UNITED STATES PATENT AND TRADEMARK OFFICE

APPLICATION NO.	FILING DATE	FIRST NAMED INVENTOR	ATTORNEY DOCKET NO.	CONFIRMATION NO.
10/027,643	12/20/2001	Mario Tokoro	450100-4780.1	1487

Office Action Summary

DETAILED ACTION

FIG. 1

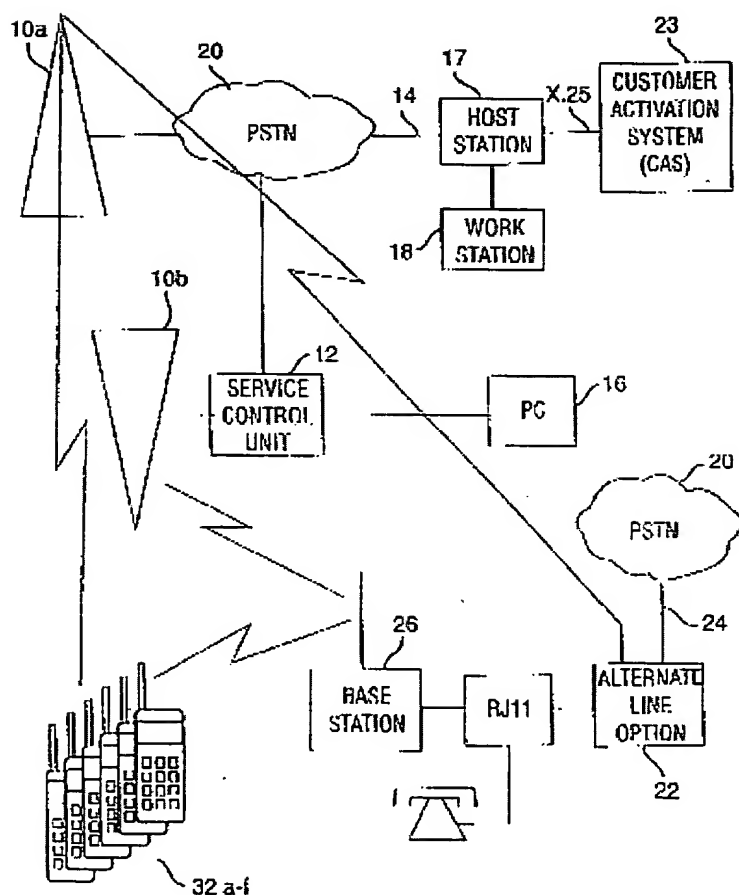
Zicker, et al disclose a first communication device (figure 1, #32) employed in a communication system. The first communication device (#32) comprising a first communication means (figure 2) communicating with a first source by using a first communication system (#10a, 10b, #12). A second communication means (*"To cooperate with the overlay cells*

a base station, referred to hereinafter as a pico station, is provided at each customer site. Each pico station is designed to support up to six improved portable handsets which function in dual modes. In a first mode each handset functions as a normal portable network or cellular telephone, when it is physically removed from the proximity of the pico station. A second wireless mode of operation is described herein for the handsets of the system which has been referred to herein as enhanced cordless on the first iterations and will be referred to as the pico mode in subsequent usage. The enhanced cordless mode of this invention differs from the operation of standard cordless telephones in several respects. This system employs a unique burst mode communication control protocol between the handsets and the pico station which is not found in standard cordless operation. This protocol is compatible with cellular standards to permit dual mode operation which would not be possible with standard cordless. Moreover, the standard cordless frequency arrangement is obviously different from cellular frequencies used in this system. Other differences will become apparent from the description that follows, which result in operational improvements in the service offered.) for communication with a second communication device (#26) and control means (#53 and 58) for controlling the first and second communication means.
